STAFF RECOMMENDATION

NCPC File No. 7055

HIRSHHORN MUSEUM AND SCULPTURE GARDEN SEASONAL INFLATABLE PAVILION

March 25, 2010

Diagram showing views of “Soufflé” concept from north and south sides of Hirshhorn Sculpture Garden

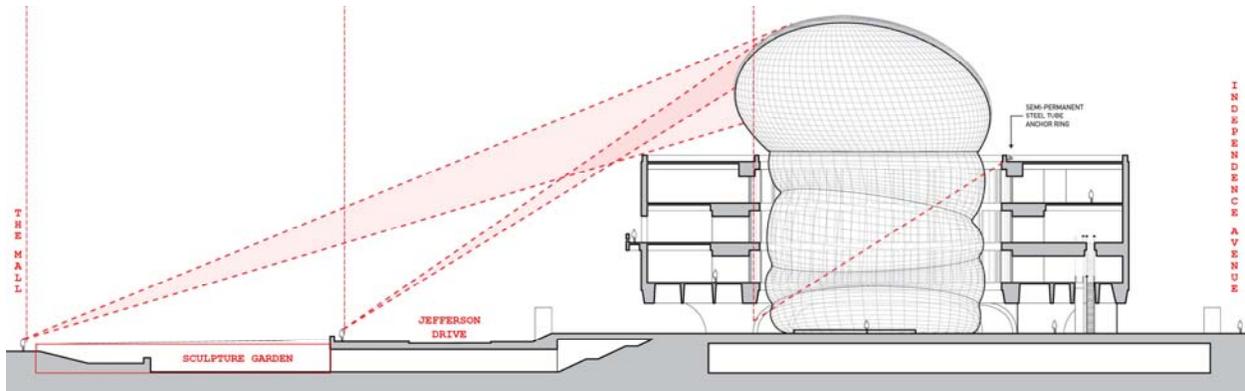
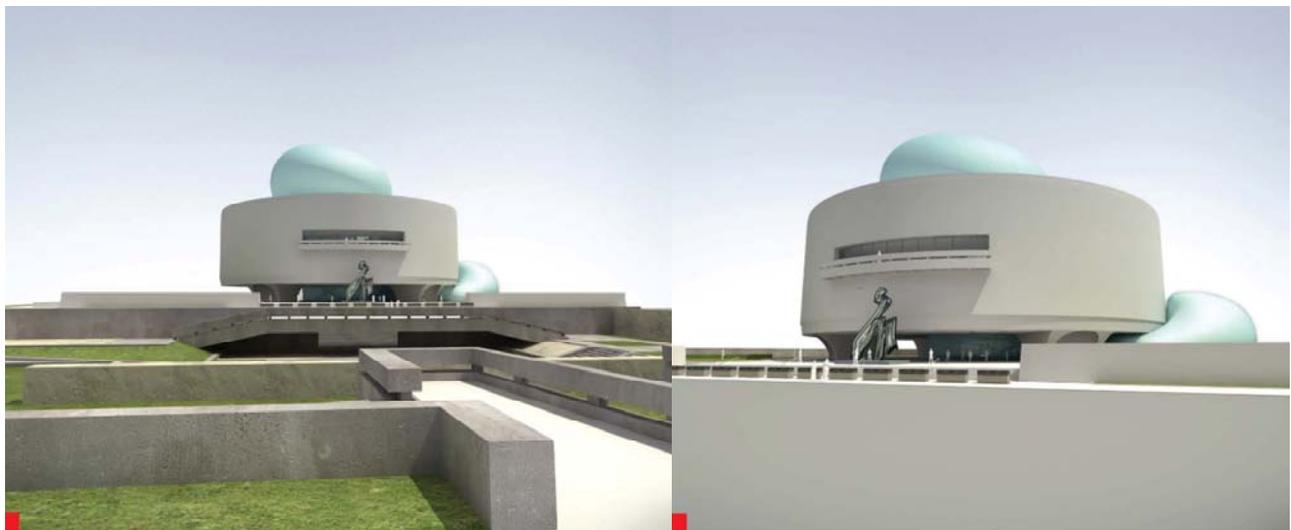
Staff has reviewed both concepts submitted by the Smithsonian and finds that additional information is necessary in order to fully analyze the potential impact of the proposed pavilion on views and vistas along the Mall, from the U.S. Capitol, along Independence Avenue, and from vantage points both north and south of the project site. The Smithsonian has provided staff with some information that addresses the “Soufflé” concept’s visibility from the Mall. According to this information, the top and café portions of the pavilion

will be visible from the Mall, but the semi-permanent anchor ring on the roof of the museum will not. The project appears to respect the general height, scale, pattern, and established building lines of buildings along the Mall and Independence Avenue. In addition, the pavilion will not extend beyond the outer roof line of the existing building, and its proposed height is consistent with its surroundings. The combined height of the museum and pavilion will not exceed 122 feet, the same height of the dome of the National Museum of the American Indian, and lower than what would be permitted by the 1910 Height of Buildings Act as measured from Independence Avenue¹.

Therefore, additional information is needed in order to fully understand any potential impacts of the proposed seasonal inflatable pavilion on views and vistas along the Mall, Independence Avenue, and from other vantage points such as along 7th Street. This analysis should take into account the daytime and nighttime visibility of the pavilion, mechanical equipment to be installed on the museum roof or at the ground-level, and any structure necessary to secure the pavilion.

Diagram of potential lighting scheme for "Soufflé" concept

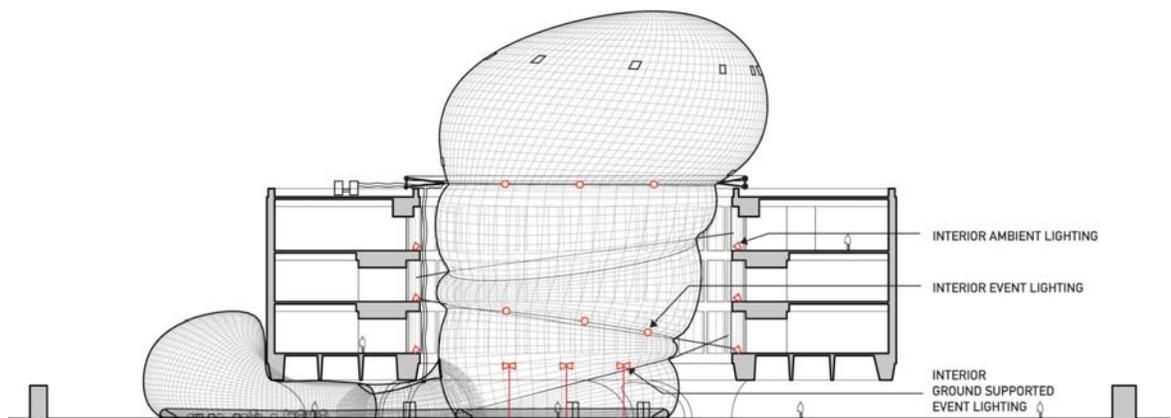
Similar to the discussion of views and vistas, staff finds that as the project advances additional information would be helpful in assessing the project's potential impacts on the National Mall and its surroundings with respect to light and noise. According to the information provided by the Smithsonian, "the translucent membrane of the pavilion will allow natural light into the event space during the day, and at night it will exude a gentle glow from within that will not compete with the monuments of the National Mall." While staff believes the pavilion will make a positive contribution to the nighttime image of the nation's capital, it is important that it do so while respecting the hierarchy of nighttime illumination that exists for the National Mall and its surroundings. In order to ensure that this hierarchy is maintained, additional analysis will be necessary prior to the Commission taking a preliminary and final action on the project. This analysis should include nighttime renderings of the pavilion, and quantitative information pertaining to illumination levels of the pavilion and major features on and around the National Mall.

Diagram of inflation and ventilation scheme for “Soufflé” concept with examples of equipment

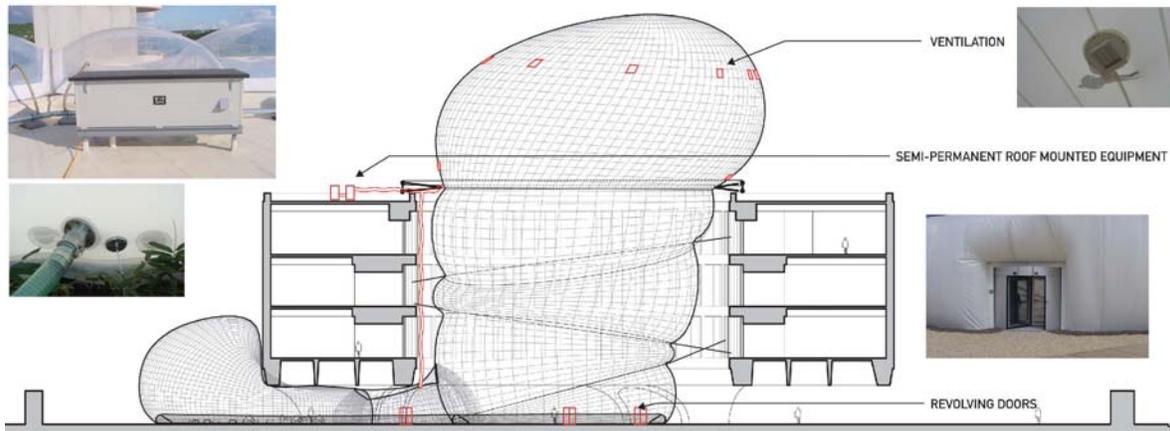
Installation of the proposed pavilion will require the placement of semi-permanent inflation, ventilation, and drainage equipment on the roof of the museum building. This equipment is necessary to sustain adequate air pressure inside the pavilion, maintain air quality, and accommodate any additional stormwater runoff. Based on the information provided by the Smithsonian, it is unclear how often this equipment will need to run, the level of noise that it will create, and what impacts this noise will have on the National Mall and its surroundings. Therefore, staff requests additional information on the mechanical equipment required for the pavilion including the frequency with which it will run, and what impacts it may have on the Mall with respect to views and noise.

“Soufflé” concept site plan and rendering of south side of café looking north toward the Mall

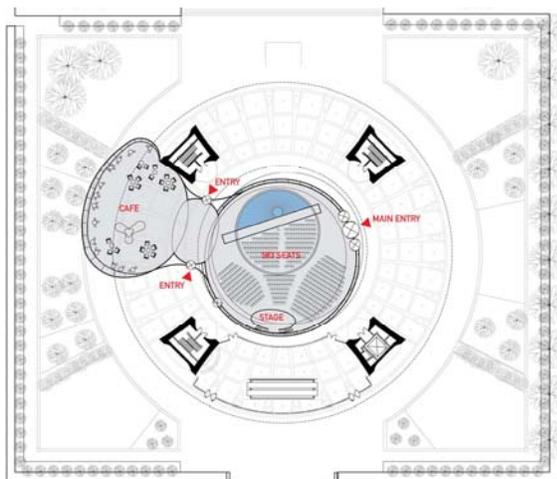
Staff’s analysis of the proposed concept identified a few areas where impediments to pedestrian circulation and ADA access may result. This is particularly true with respect to the “Soufflé” concept. As proposed, this particular concept appears to significantly reduce pedestrian movement around the western half of the project site. The enclosure of the central courtyard eliminates this space as a “pass-through” for pedestrians accessing the museum, and moving between the Mall and Independence Avenue. In addition, due to the location and size of the café, it appears that pedestrians will not be able to make their way around the west side of the museum building without having to walk along the outer edge of the plaza, or stepping onto the grass panels that contain some of the museum’s sculpture. These impediments are compounded even more given that the only active entrances to the museum, one revolving door and one ADA compliant entryway, are located at the southwest side of the building. Staff notes that pedestrians would be able to travel through the two entryways located between the auditorium and the café, but that this could potentially be confusing to museum patrons, create a bottleneck, and be disruptive to events taking place in the pavilion.

Staff acknowledges that this project is still in the concept stage and that many of the design and program details will be resolved as the project advances toward a preliminary and final design. Therefore, staff encourages the Smithsonian to take these observations into consideration while refining its designs, and deciding which concept to pursue further. Furthermore, staff requests that the Smithsonian specifically address the issues of pedestrian circulation and ADA accessibility at the next stage of review.

Steel tube anchor ring on roof of museum

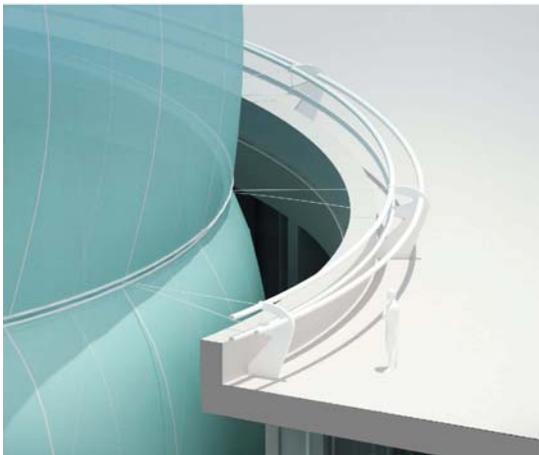
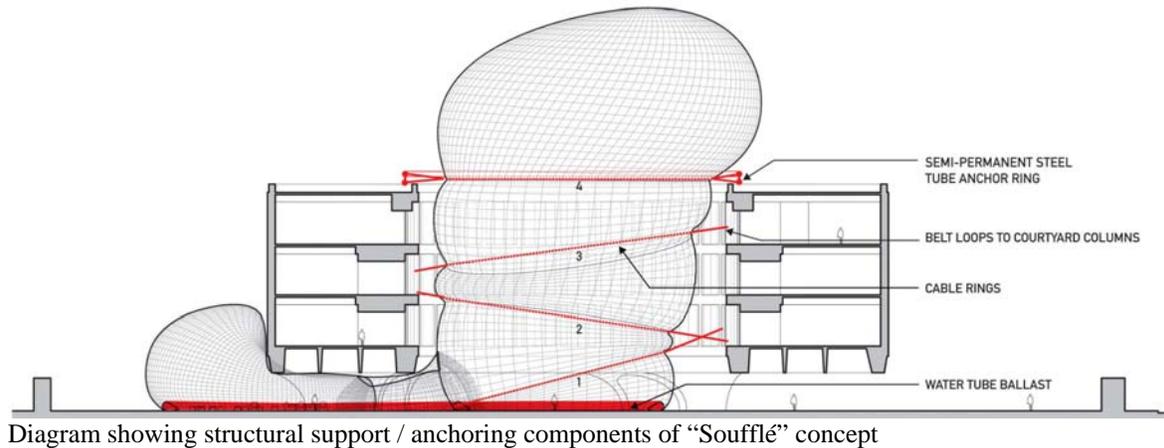
Because it is less than 50 years old, the Hirshhorn Museum and Sculpture Garden is not yet eligible for listing in the National Register of Historic Places (NRHP). However, given that its design embodies distinctive characteristics of the Modernist movement, and that it represents the work of someone considered to be a “master” in the design arena - two characteristics that could qualify the Hirshhorn for listing under Criteria C of the NRHP - it is important that the project proceed as if the building already merits historical significance. While the Smithsonian has indicated that the proposed concept has been designed to have a “light touch” on the existing building, courtyard,

and fountain, as the project advances staff requests that the Smithsonian submit detailed information pertaining to the full lifecycle of the proposed pavilion including: installation, anchoring, maintenance, and disassembly. This information should describe the structural components and mechanical equipment that will remain in place during the times of the year that the pavilion is not in use, and how each of these components will attach to the existing building. It should also describe whether any permanent alterations will occur to the site as a result of the project. This information will assist staff in determining whether the project will have any impacts on the architectural integrity of the existing building.
